Rezoning Application:

MM 21-0944

**Hillsborough
County Florida**

Development Services Department

2.4 Proposed Site Plan (partial provided below for size and orientation purposes. See Section 8.0 for full site plan)

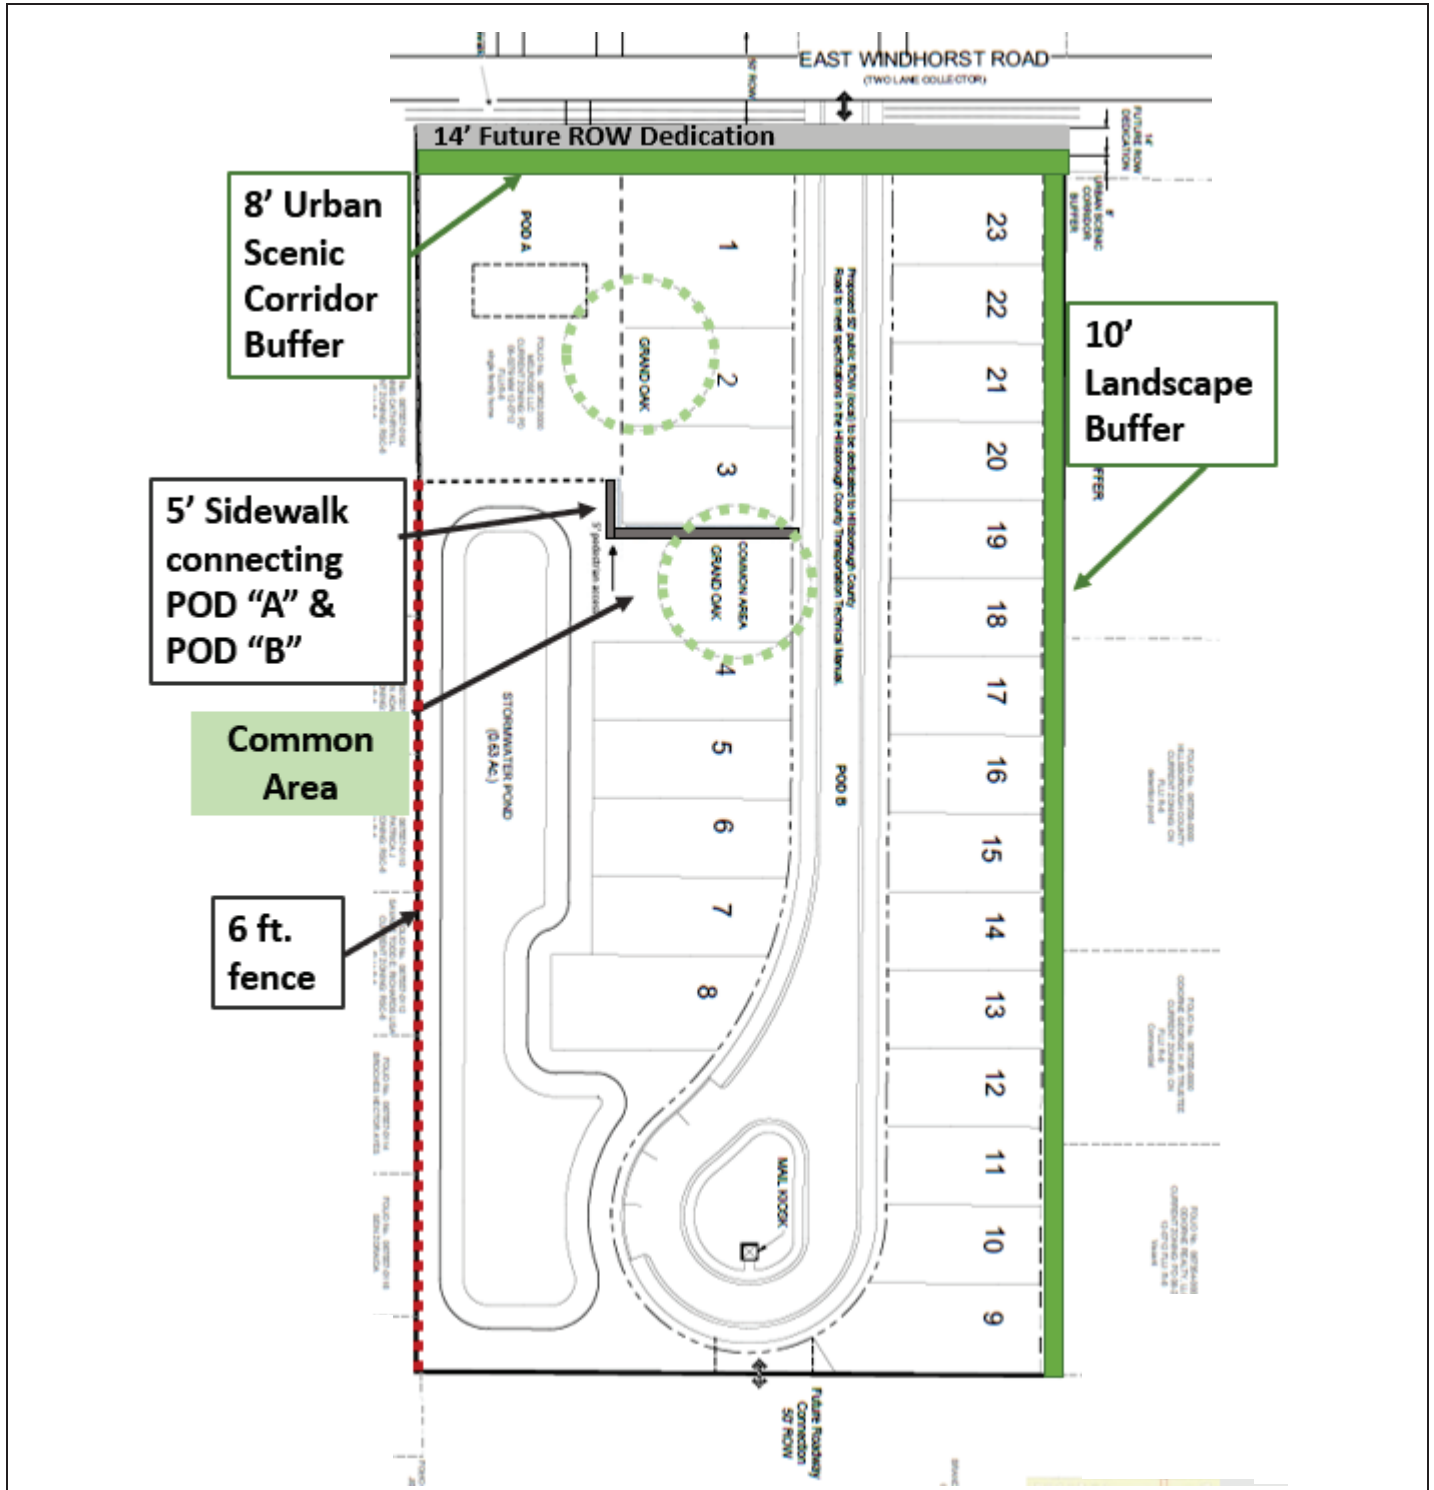
The homeowners will have screening and buffering to block the view of this element. The applicant has stated that fencing and plant material will be installed to provide privacy and screening between the two properties. Staff proposes a condition to ensure future residents are buffered against the adjacent uses. It should also be noted that a portion of the eastern boundary is the location of a Hillsborough County owned retention pond, which does not require a buffer, but the applicant has proposed to have a consistent buffer on the eastern lots.

GENERAL SITE PLAN REVIEW/CERTIFICATION

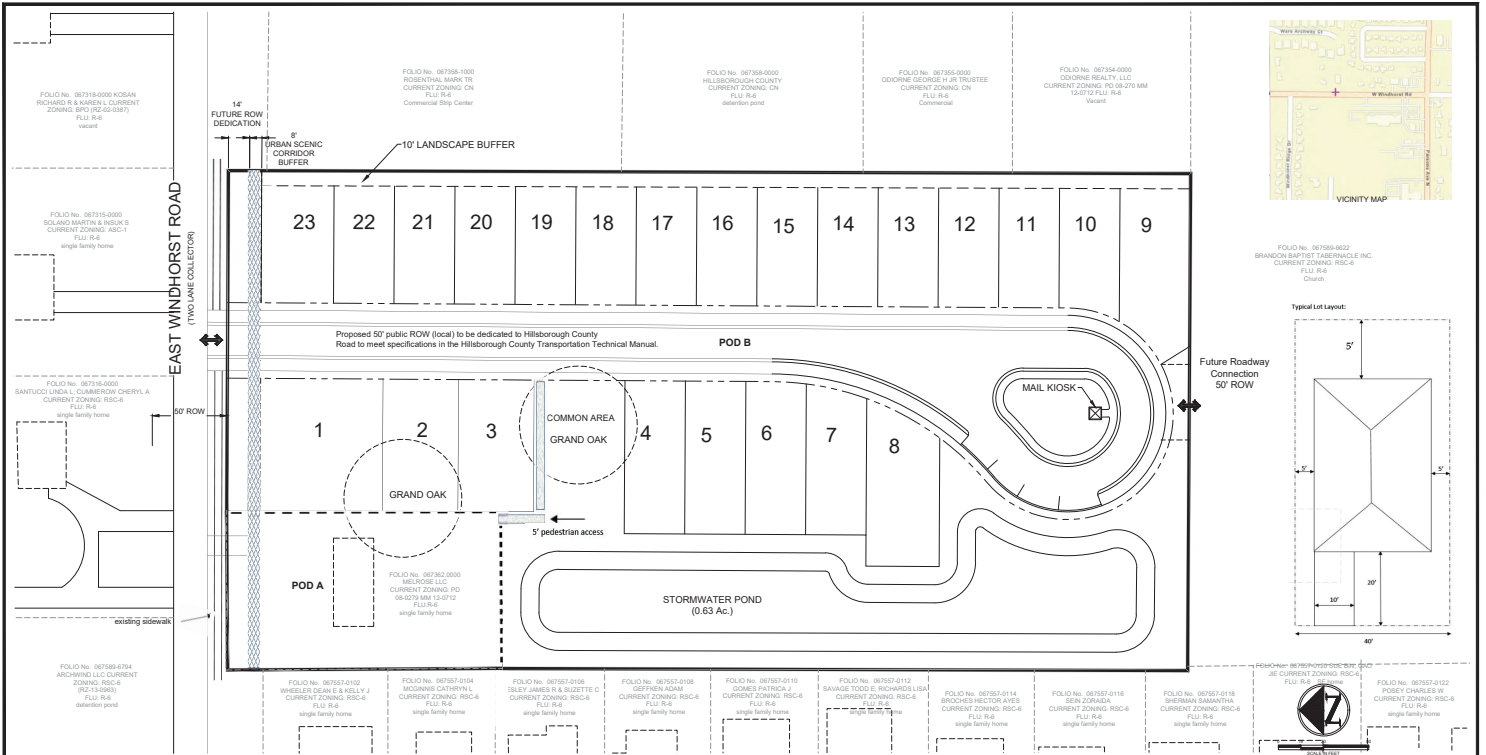
Prior to PD Site Plan Certification, the applicant shall revise the PD site plan as follows:

- Re-label “East Windhorst Road” to West Windhorst Road.
- Revise the language “Future Roadway Connection 50' ROW” to Access Stubout – See Conditions of Approval.
- Remove Urban Scenic Corridor Buffer graphic from the proposed 50ft public internal roadway.
- Within the Legend, replace “Future Access Point” with Access Point.
